AMENDMENT TO
PUBLIC AGENCY PERMIT

13715 STREET
SACRAMENTO, CALIFORNIA 95814 DraftNEGATIVE DECLARATION

Project Title: Chevron El Segundo Groin and County Outfall Extension

MITIGATION *

FIGURE 1
FIELD SAMPLING PROGRAM
VIBRACORE LOCATIONS

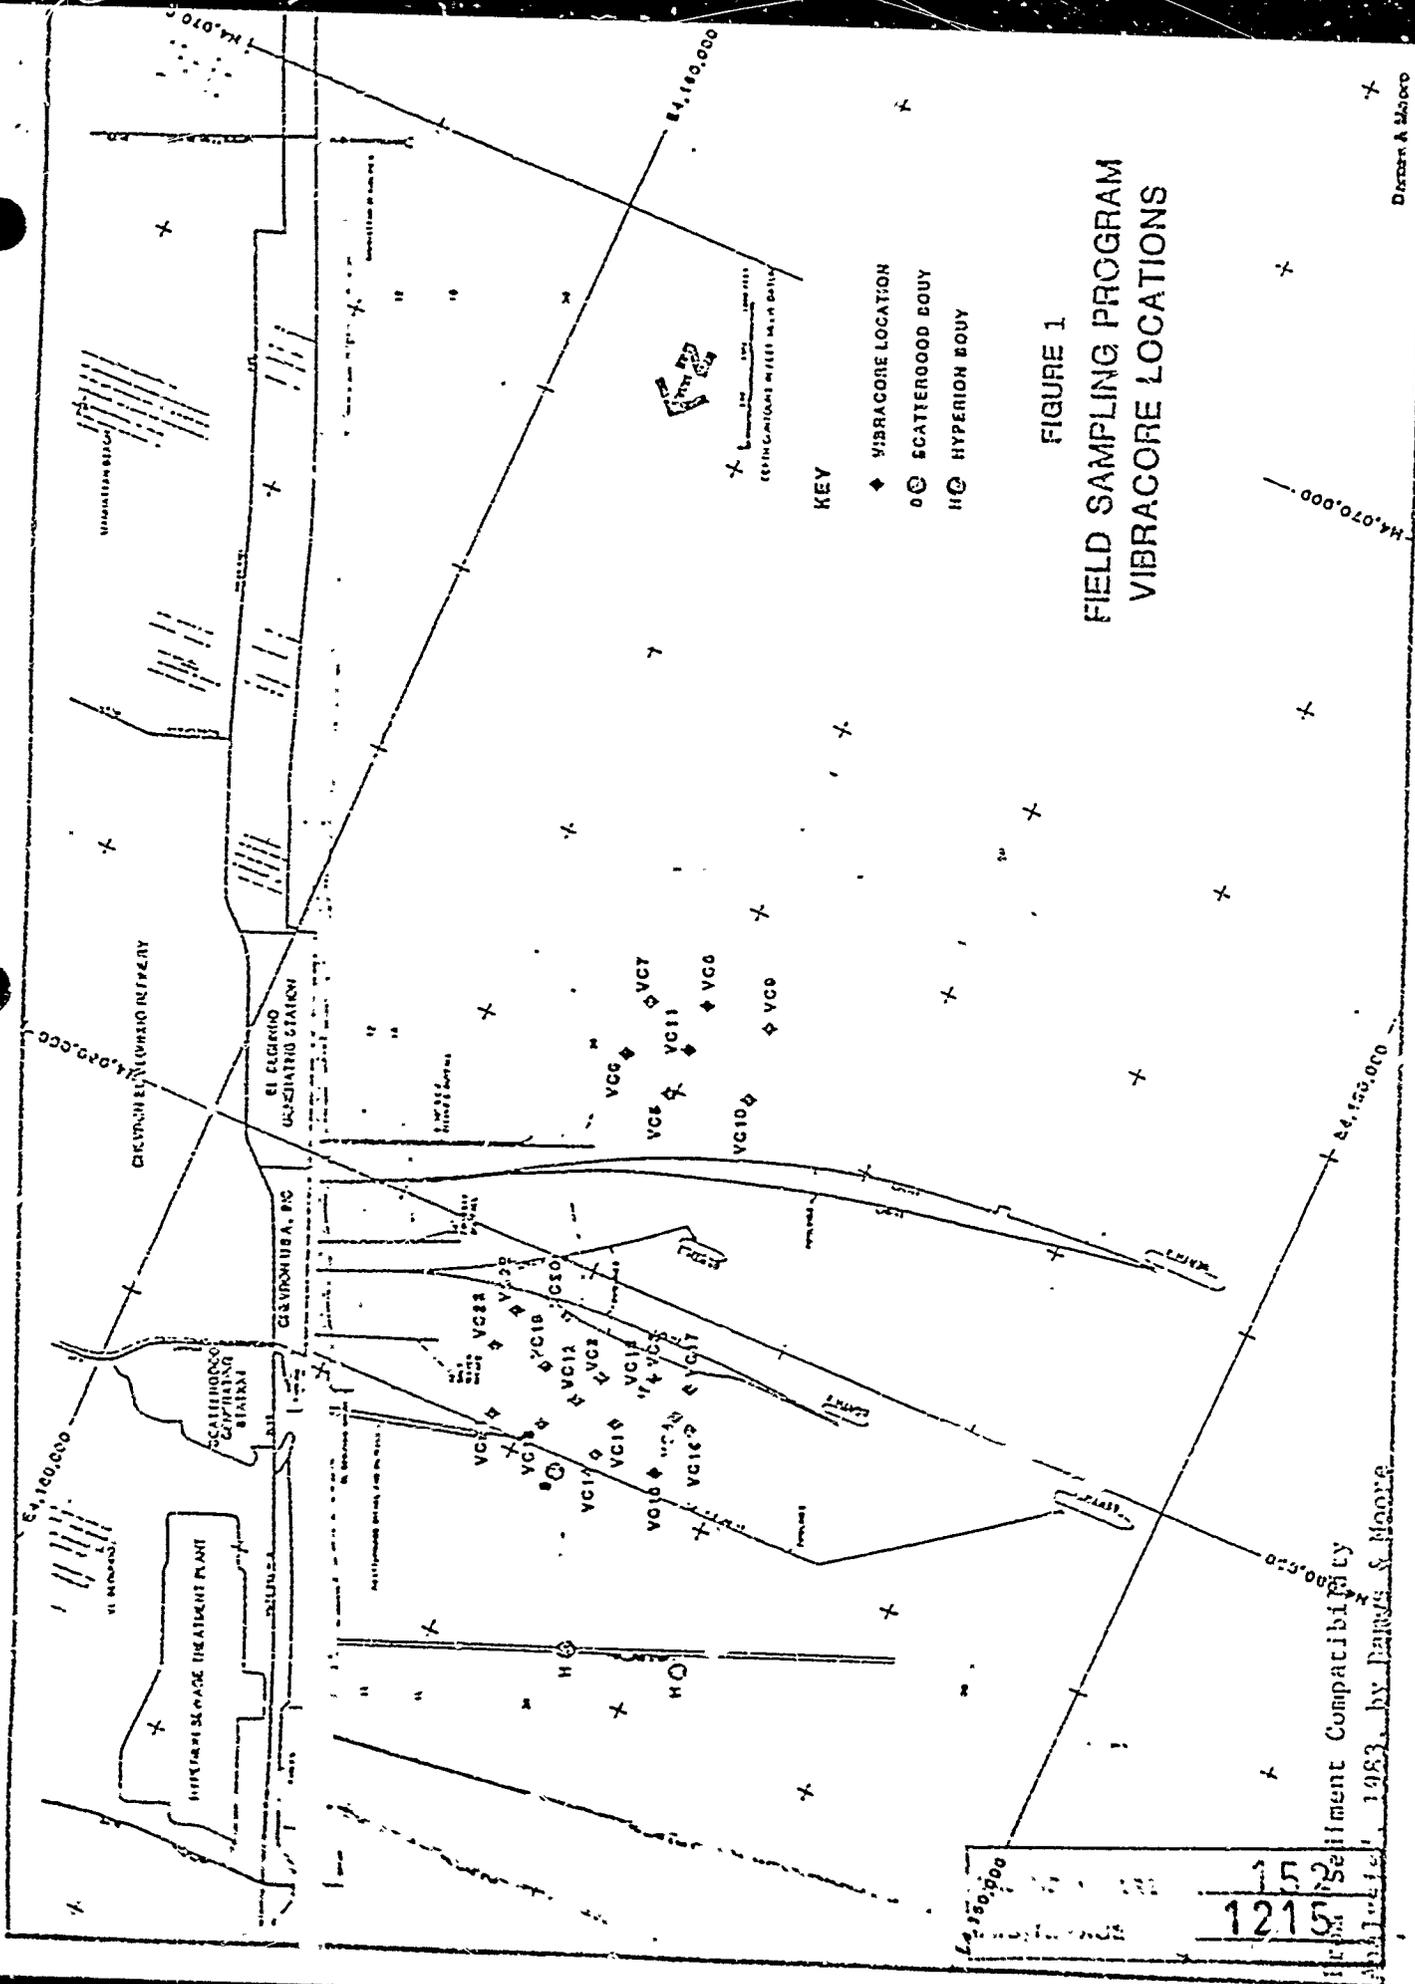
The question was raised of the compatibility of the borrow source material for the beachfill site. As mentioned previously, Dames and Moore made a sand compatibility study based on a program of 24 offshore core samples in December 1982 and January 1983. This report was submitted to the U.S. Army Corps of Engineers (COE) in March 1983. Following is a summary of the results of this report.

Figure 1 presents a drawing of an outline of the proposed borrow area with north-south and east-west cross-sections. This outlined surface area represents approximately 284,000 square yards. Sixteen vibracores between 3½ and 11 ft in length were obtained from this area. This number is in excess of the 11 vibracores required by the following formula presented in the COE guidelines:

FIGURE 2
 BEACH PROFILE
 MONITORING
 POINTS

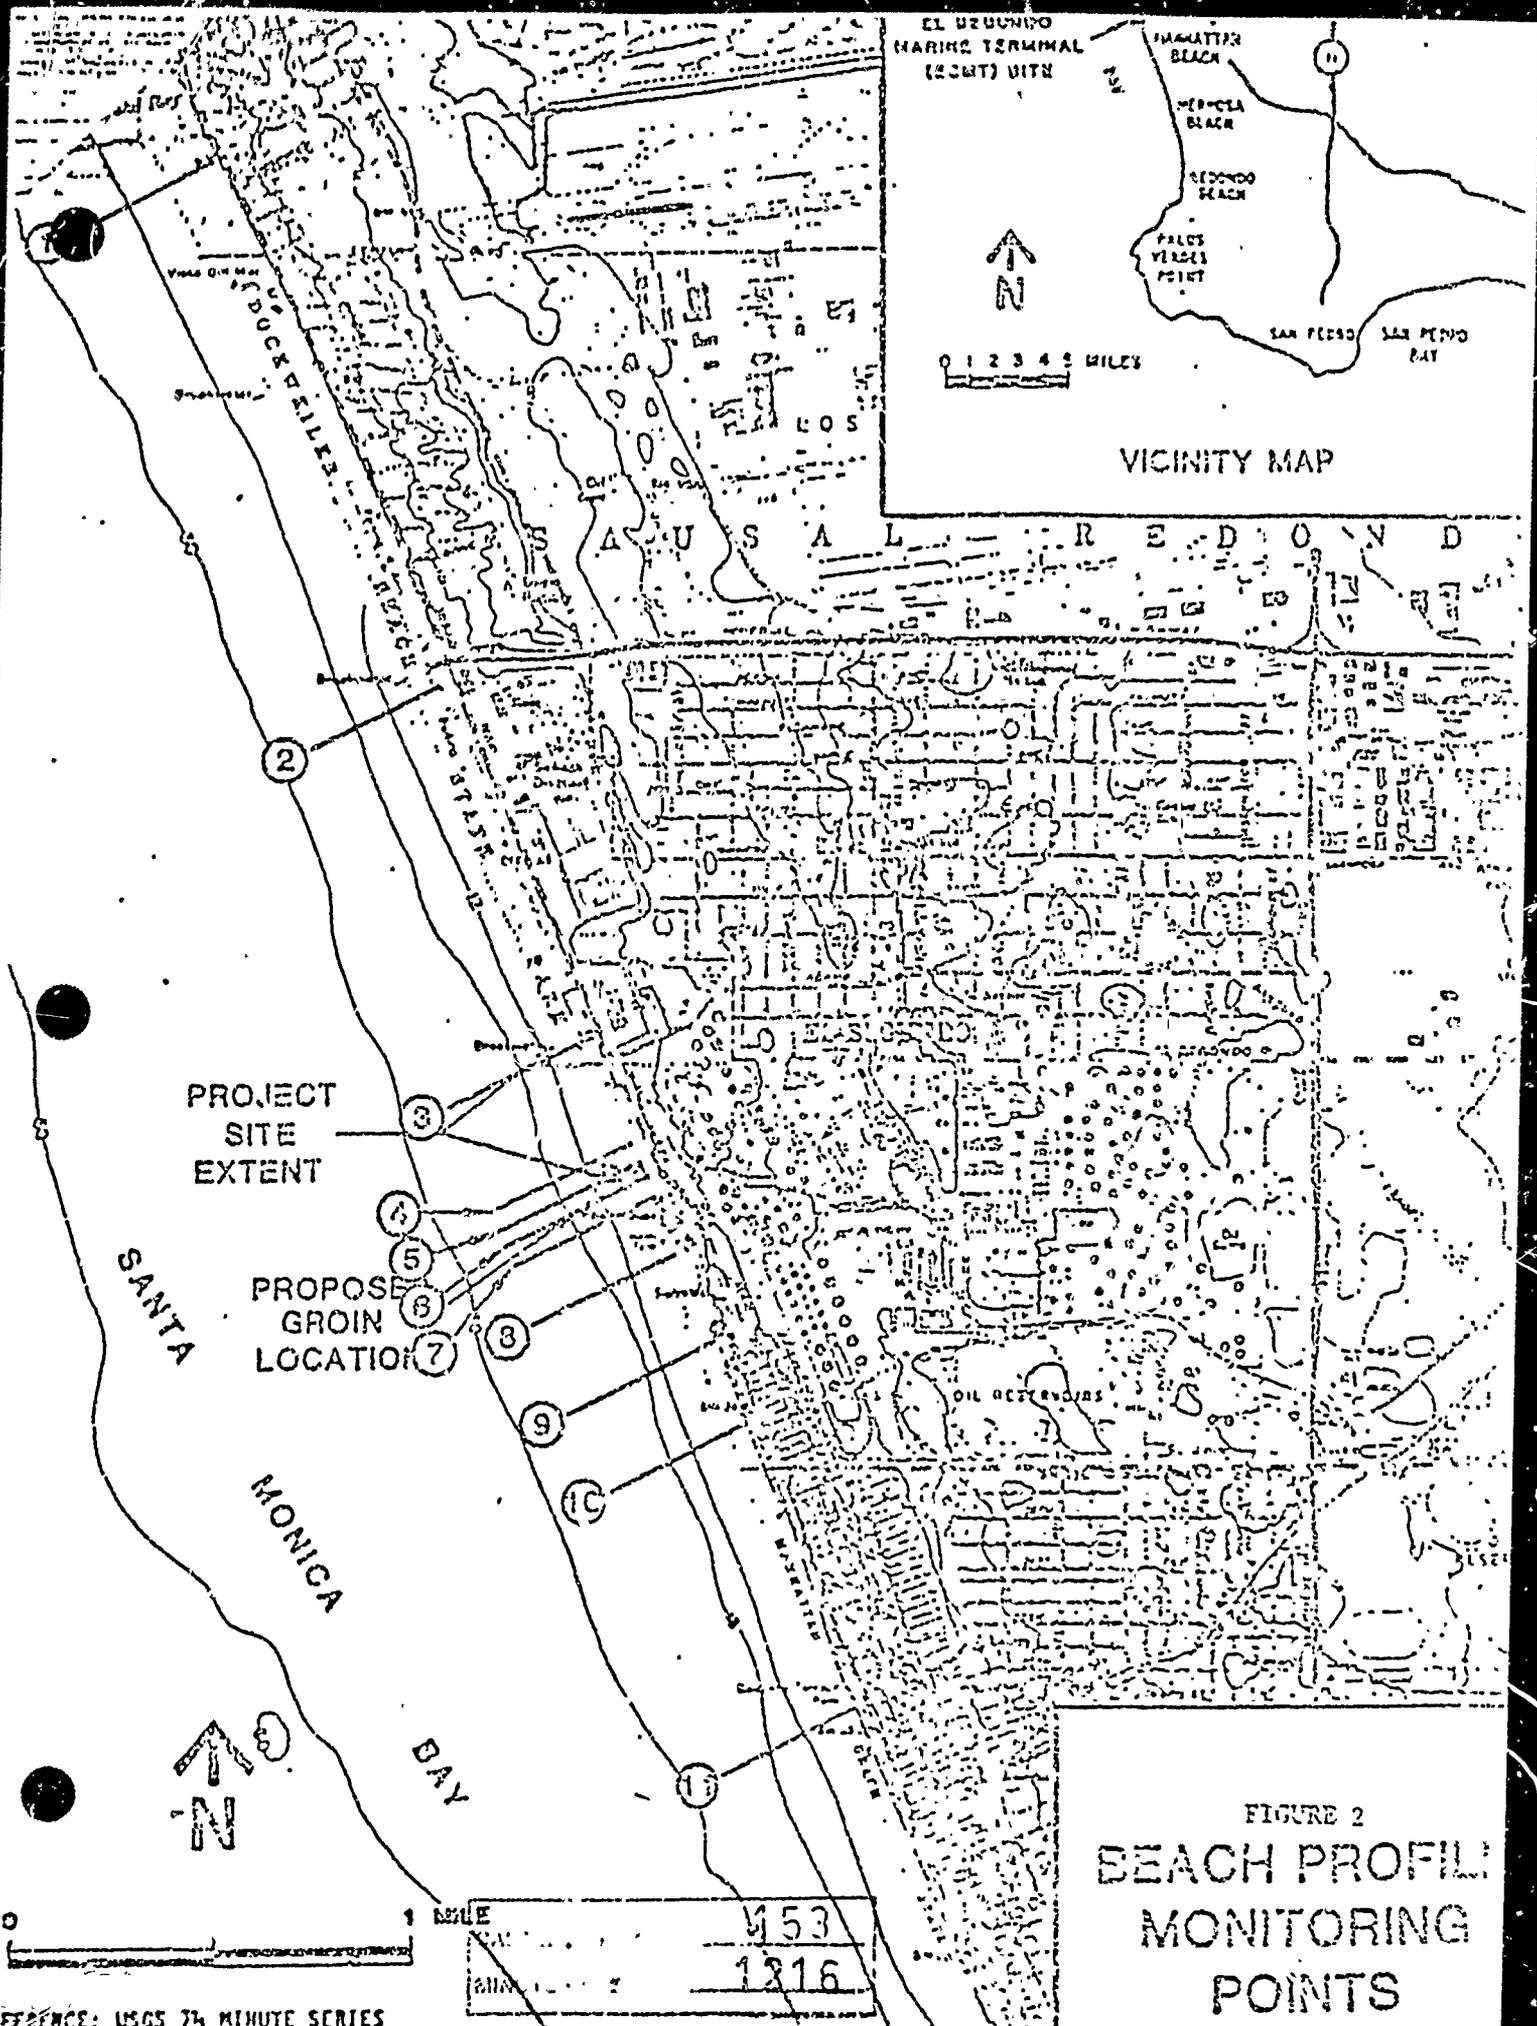
Chevron's primary design criteria has always been to avoid erosion on down coast beaches. Design alternatives which ignored this consideration were disregarded. Chevron's analysis of the design and sand pre-fill characteristics has been substantiated by third party experts in the field: Mr. John Hale, the designer of the proposed project, and Dr. Bernard Pipkin (See Appendix).

Chevron has developed a monitoring program which addresses down coast erosion and will detect any increase caused by the Chevron groin. The program is based on a survey of twelve (12) beach profiles from Playa Del Rey to Hermosa Beach (See Figure 2). These surveys will be taken semi-annually the years before and after construction and annually in August thereafter. This data will be analyzed by a third party consultant and a report prepared annually for at least five years. The analysis will consist of a determination of sand volume changes from year to year at depths from 0'MLLW to -25' ML. Changes will be compared between above groin profiles and below groin profiles. In the unlikely event that the consultant determines that a direct cause-effect relationship does exist between the presence of Chevron's groin and downcoast erosion, Chevron will take remedial action. Such action would have to be determined at the time, but could include beach nourishment, breach of a portion of the groin, a sand bypass system or repair of erosion-damaged property. The percentage of erosion attributed to the groin would establish the percent financed by Chevron. Chevron believes the design is sound, and that the annual analysis will substantiate this.

FIGURE 8: ESTIMATED OCEAN BOTTOM DEPTHS, A COMPARISON

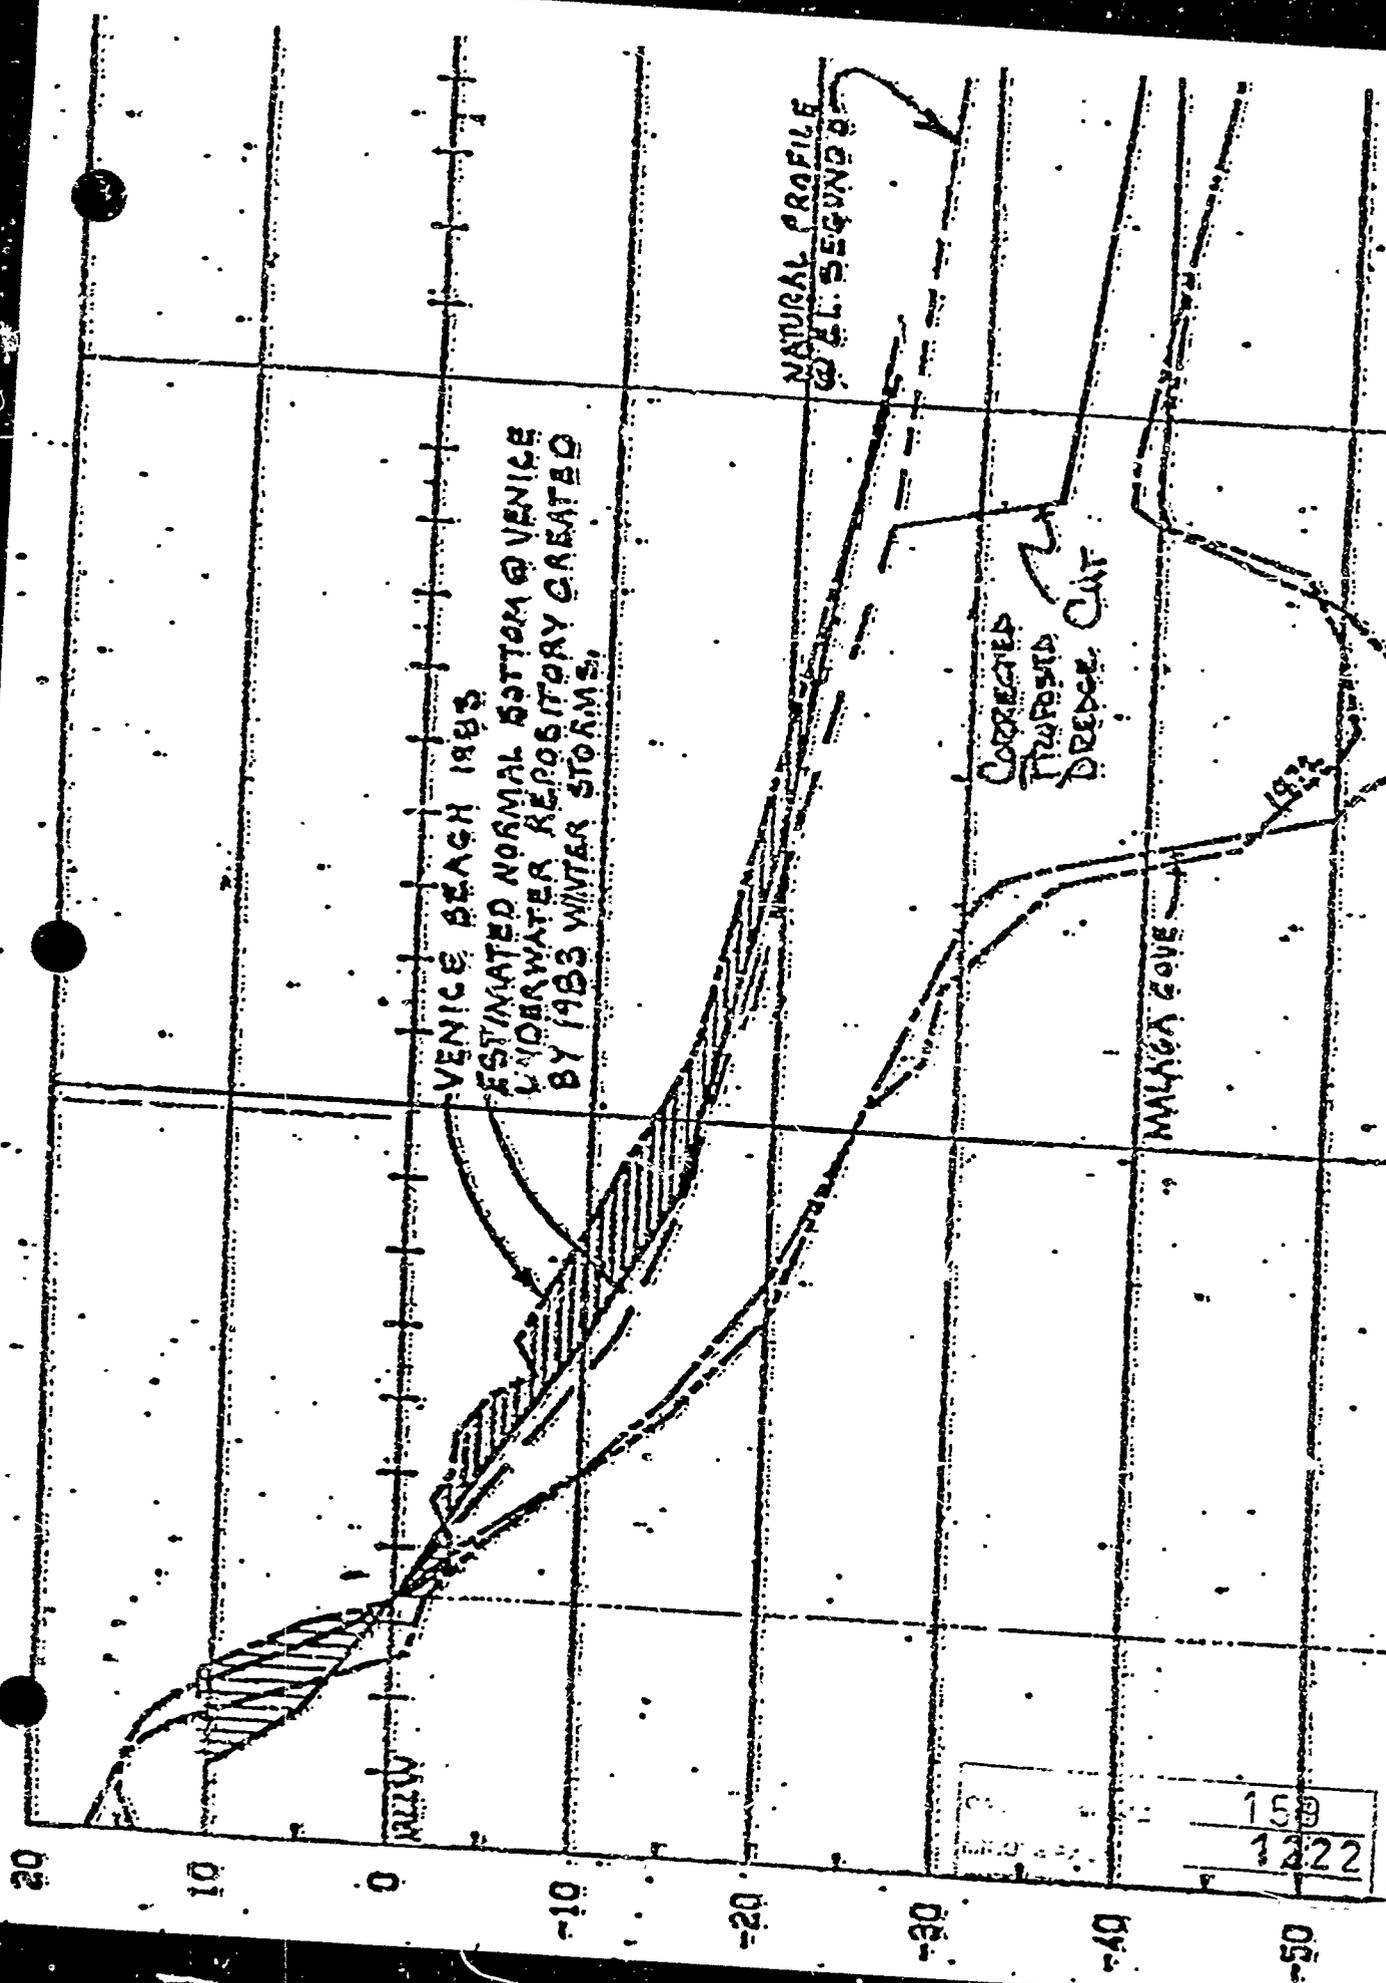
Concern has been expressed that the dredge borrow site is located too close to shore and will fill in with material drawn offshore from the beach fill. This would cause a deficit in sand carried in the longshore transport system, which would potentially result in increased down coast erosion. In support of this concern Los Angeles County Engineer - Facilities Department prepared several profiles depicting the Redondo-Malaga Cove dredge depression, the proposed El Segundo dredge depression and pre and post 1983 storm profiles near Venice beach (see Figure 8). In preparing the Figure, the County states that the Initial Study presents conflicting data on the inshore limit of the proposed dredge source. Since this data was used to formulate their conclusions, the following paragraph is presented to clarify the data.

The County's report refers to Page 64 of the Initial Study which indicates -25 ft MLLW at 1250 feet, while Figure 19 (from Initial Study) indicates -30 MLLW. The inshore limit of the proposed dredge cut is defined as -25 ft. MLLW. The length of the beach parallel dredge cut (north to south) is approximately 1,250 ft. This is not the distance from the shoreline (which presently is approximately 1,500 ft from the shoreline to the inshore limit of the dredge cut). The County selected Figure 19 from the Initial Study, to base their profiles of the proposed El Segundo dredge cut. Since this is a schematic drawing, scaling data from this figure is inappropriate. Chevron has have revised the County's Figure II (see Figure 8 of this report) to reflect a correct representation of the proposed dredge cut profile.

As shown on Figure II, a considerable amount of material has been drawn offshore Venice beach as a result of the 1982/1983 winter storms. The seaward limit of this storm includes offshore movement of material is shown in Figure 8 to be approximately -22 ft MLLW and only a small fraction (5 percent) of the total volume is seaward of -30 ft MLLW. Since the dredge cut will be seaward of -25 ft MLLW, there is little chance that any significant offshore transport of material will be drawn into the dredge depression by storm events and not returned to the active littoral zone. The profiles presented by the County for Venice Beach are typical of profiles we have examined in Santa Monica Bay that all indicate the seaward limit of active on-offshore littoral movement is in the range of -17 to -22 ft MLLW. The shoreward limit of dredge cut was selected after examination of historical beach profiles, wave data and operational limits of available dredging equipment.
